UNITED STATES
NUCLEAR REGULATORY COMMISSION
WASHINGTON, DC 20555 - 0001

SUBJECT: DIFFERING PROFESSIONAL OPINION INVOLVING ON RED OIL
EVENTS AT THE PROPOSED MIXED OXIDE (MOX) FUEL
FABRICATION FACILITY (DPO-2005-002)

DIFFERING PROFESSIONAL OPINION

DIFFERING PROFESSIONAL OPINION ON
RED OIL EVENTS AT THE
PROPOSED MIXED OXIDE (MOX) FUEL FABRICATION FACILITY
DOCKET NUMBER: 070-03098

Figure A: Comparison of the Applicant's Red Oil Safety Strategies with DOE/DNFSB (formerly Open Item CS-01) Recommendations

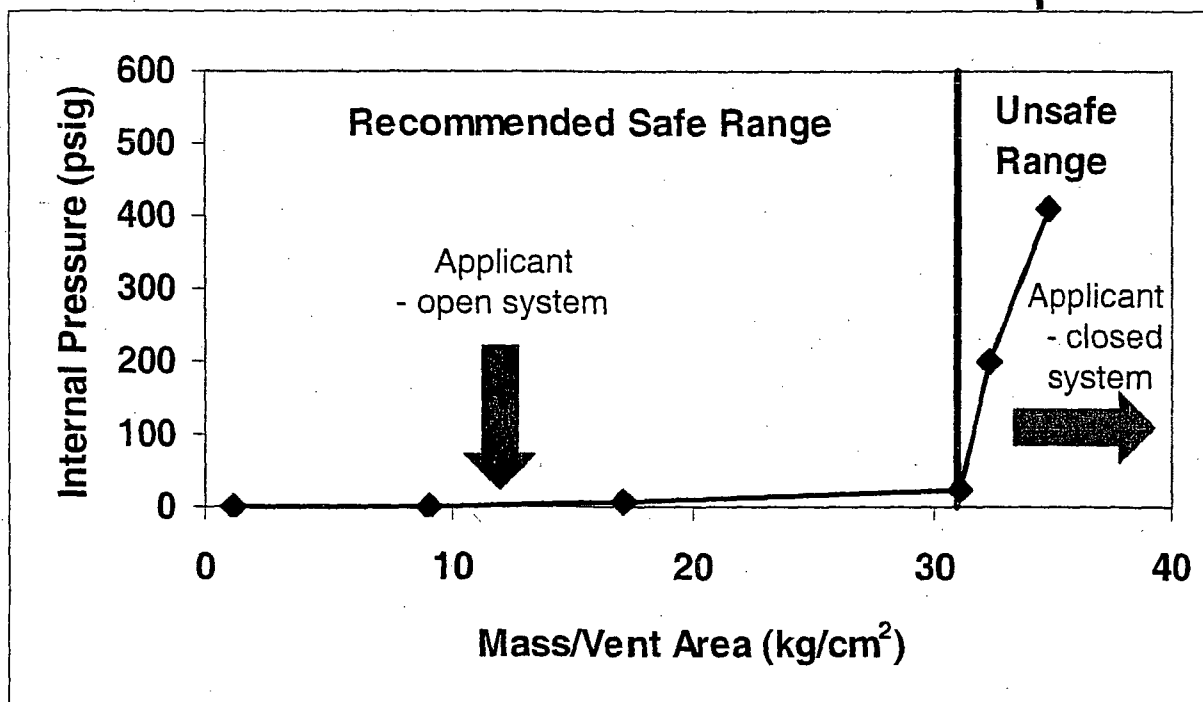
1. Contradictions with DOE/DNFSB RAGAGEP (Reasonable And Generally Accepted Good Engineering Practice) are not explained. In particular, the RAGAGEP shows the applicant's proposal for closed systems being entirely in the unsafe regime (Figure 2).
2. There is inadequate margin in the design basis temperature.
3. The venting is insufficient to avoid choked flow and pressurization, which has the ability to rapidly raise the temperature even with the applicant's proposed strategy functioning.

Figure 1: **Example of Facility Damage from a Red Oil Event - Tomsk, 1993.**

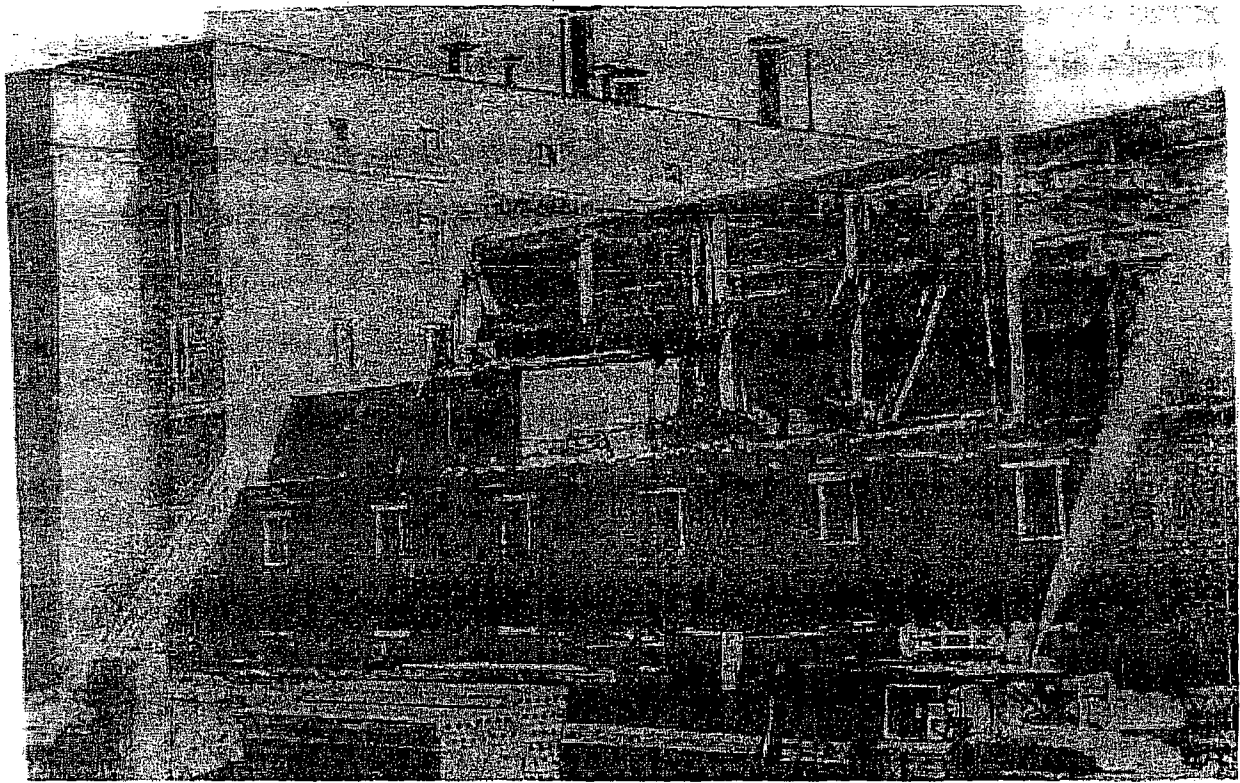
A photograph of the damage from the red oil event at Tomsk was removed from the DSER during editing. It is included as Figure 1, on the next page. Note that the event initiated in a shielded cell underneath the building, with relatively small quantities of materials reacting. Comparable quantities of organic materials could be present at the proposed MOX facility. A separate appendix on red oil events was also omitted from the DSER.

Figure 2: Comparison of the Applicant's Red Oil Safety Strategies with DOE/DNFSB (formerly Open Item CS-01) Recommendations

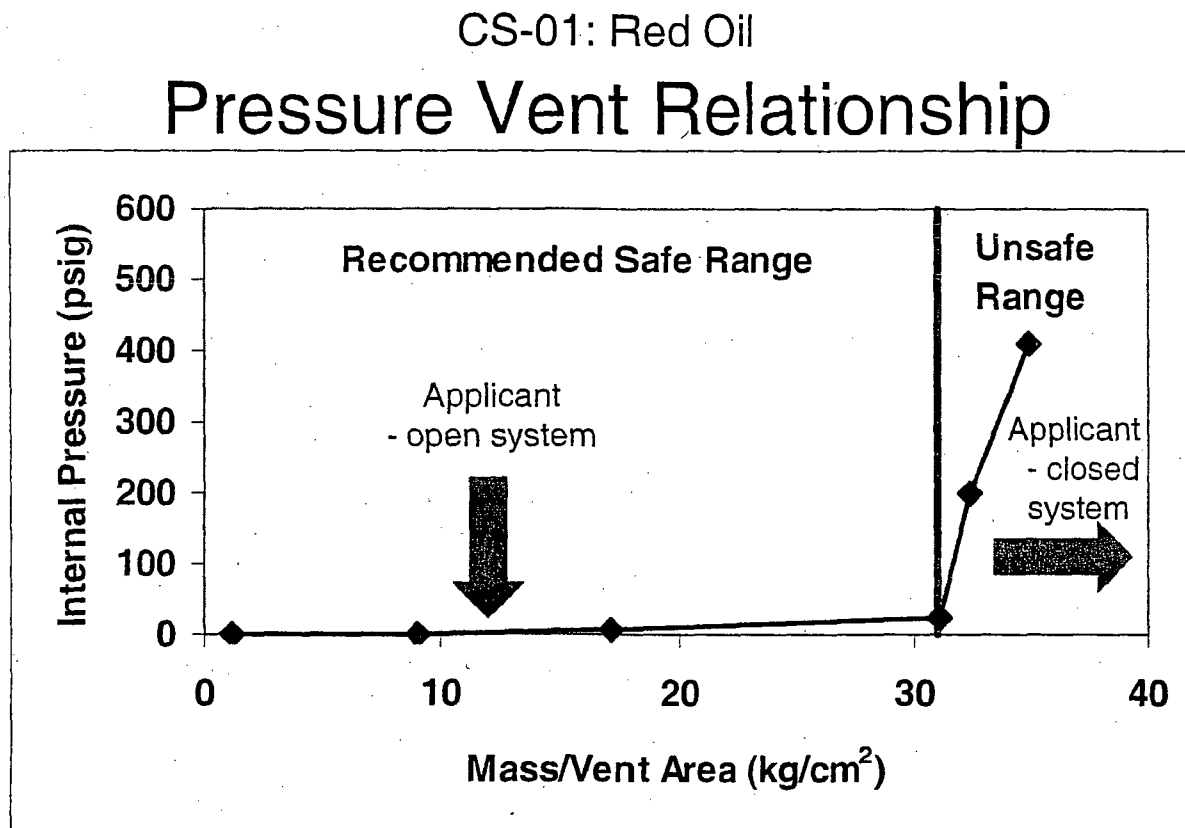
- **Pressure/Venting:** DOE/DNFSB use a pressure/vent relationship (Figure 2) that is well within the safe range identified from experimental testing. The applicant's approach for open systems is also well within the safe range. In contrast, the applicant's approach for closed systems (i.e., evaporative cooling) far exceeds the safe limit and is well into the unsafe range. Common mode failure is likely - reaction products from the red oil reactions cannot escape and provide evaporative cooling, resulting in choked flow, which increases temperature, resulting in suppressed evaporation, which increases temperature, resulting in increased red oil reaction rates etc. - ultimately, this leads to a runaway reaction and explosion. The loss of evaporative cooling effectiveness above 120 C is noted in articles cited in the staff's DSER and RDSER.

1. Contradictions with DOE/DNFSB RAGAGEP are not explained. In particular, the RAGAGEP shows the applicant's proposal for closed systems being entirely in the unsafe regime (Figure 2).
2. There is inadequate margin in the design basis temperature.
3. The venting is insufficient to avoid choked flow and pressurization, which has the ability to rapidly raise the temperature even with the applicant's proposed strategy functioning.
